project: **SOP 53 2** FIGTREE DRIVE <u>SYDNEY OLYMPIC PARK</u> Copyright of the design and other information shown here is owned by Mirvac Design pty. Itd. Reproduction or use of the design by any party for any purpose is expressly forbidden without the written permission of Mirvac Design pty. Itd. Mirvac Design Nominated Architect Diana Sarcasmo NSW: 6525, VIC:19056, OLD: 5091, WA: 2982

# COVER SHEET

Modification to SSD 7662

### MODIFICATION TO SSD 7662

drawing no: DA-3002

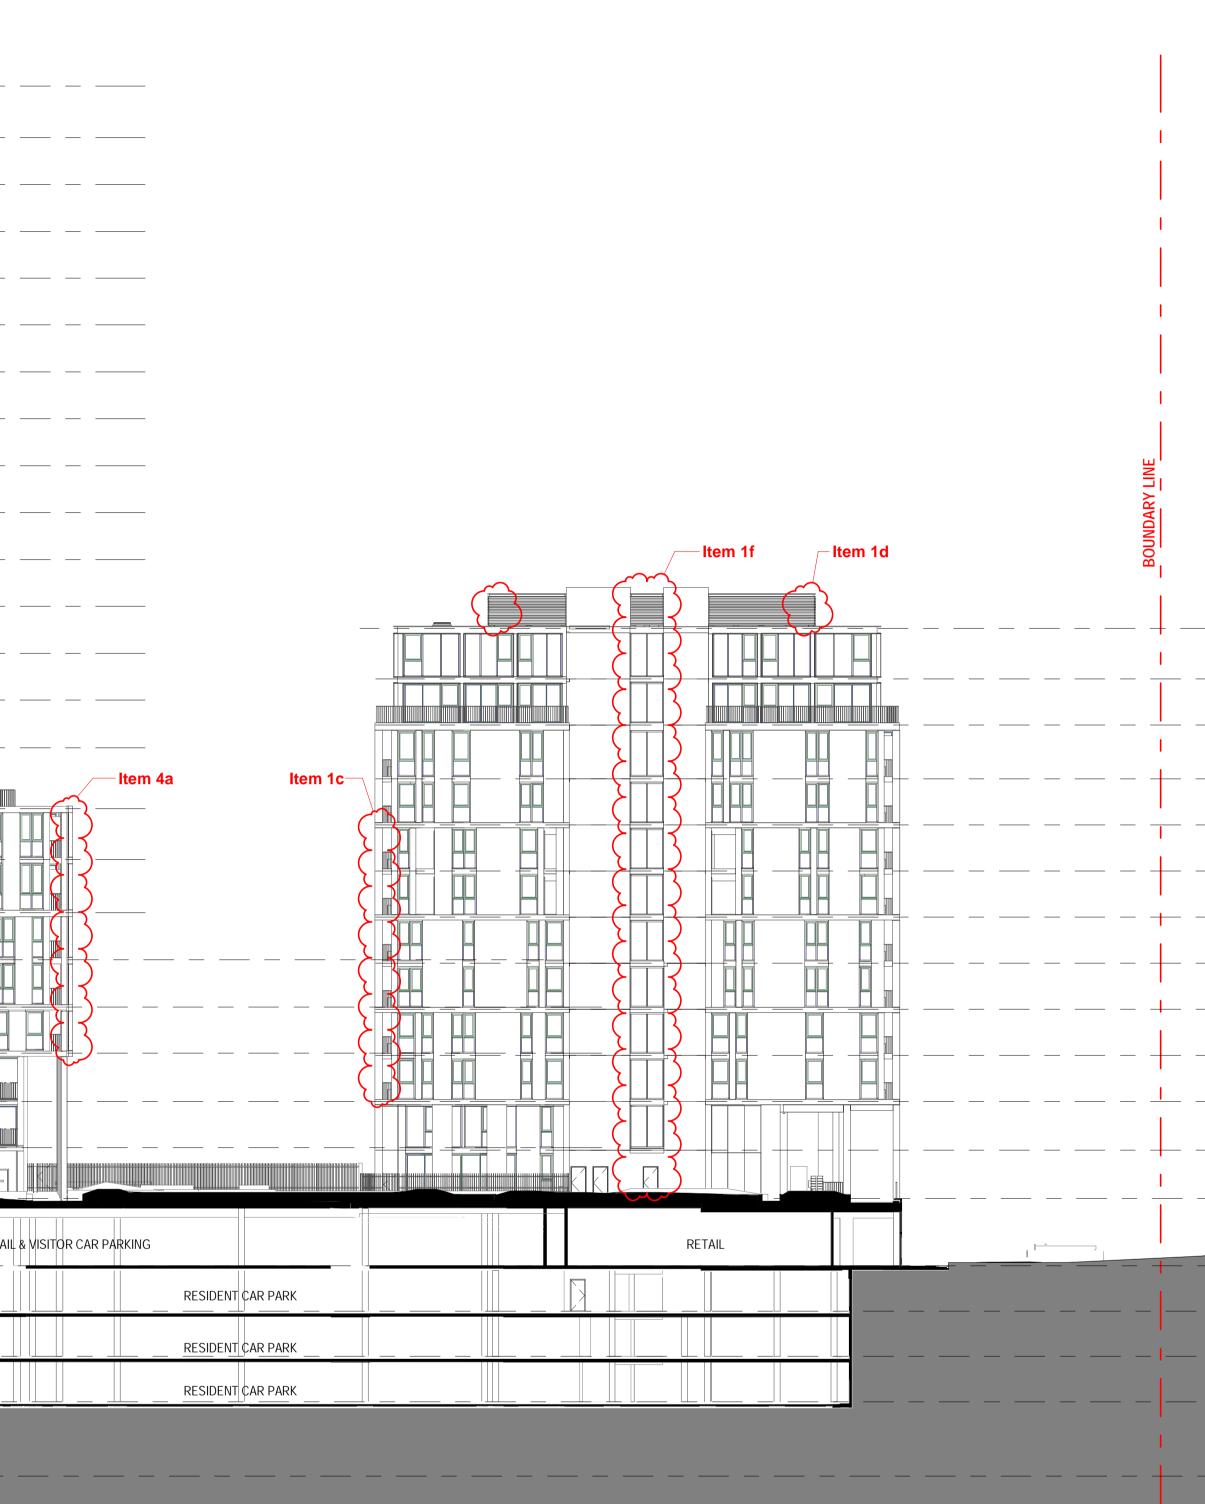
- 1a. Mechanical louvers and retail facade amended on basement 1 1b. Main pedestrian entry for Building 1 & 2 from Figtree Drive to
- L1 landscape podium updated
- 1c. Privacy screen relocated to Building 5 from Building 1
- (L3 to L8)
- 1d. Roof screen & lift overrun area revised
- 1e. Off form concrete to terraces entry portal on L1 1f. External wall nibs removed from southern facade

- 2a. Conversion of 10 x 1 & 2 Bed units to 5 x 3 Bed units on L28 to 132
- 2b. 2 x Lift doors deleted on L2 to L15
- 2c. Louvred roof removed & plant room area updated on L25
- 2d. Plant room screen & top of lift machine room updated on L36 2e. Glazing opening added to the side blade wall on L25 to
- improve amenity of apartment
- 2f. Windows location in apartment updated on L35 2g. Plant room screen added to the back of core on L1 to L16

- 3a. Awning above the entry of gym room added on L1
- 3b. Awning above substation added 3c. Roof plant screen & plant area amended on L10
- 3d. Gym/Yoga Studio & Community Room location swapped on L1
- 3e. Courtyard to apartment added on L1
- 3f. Balcony in apartment updated on L8 3g. Roof plant screen reduced on L8

- Leasing Office on L9
- 4g. Plant room area relocated and louvred roof removed on L25 4h. Courtyard to apartment added on L1
- 4i. Off form concrete to terraces entry portal on L1

- 4j. Inclusion of workshop/storage in bicycle storage on L1 4k. Facade amended to suit approved DA floor plan
- BASEMENT
- 5a. Relocation of car parking spaces in basement levels

- 5b. Basement outline amended
- 5c. Main switch room relocated to B2
- 5d. Cold water plantroom relocated to B1
- 5e. Bicycle storage / parking added to B1 5f. Parcel locker area added to B1
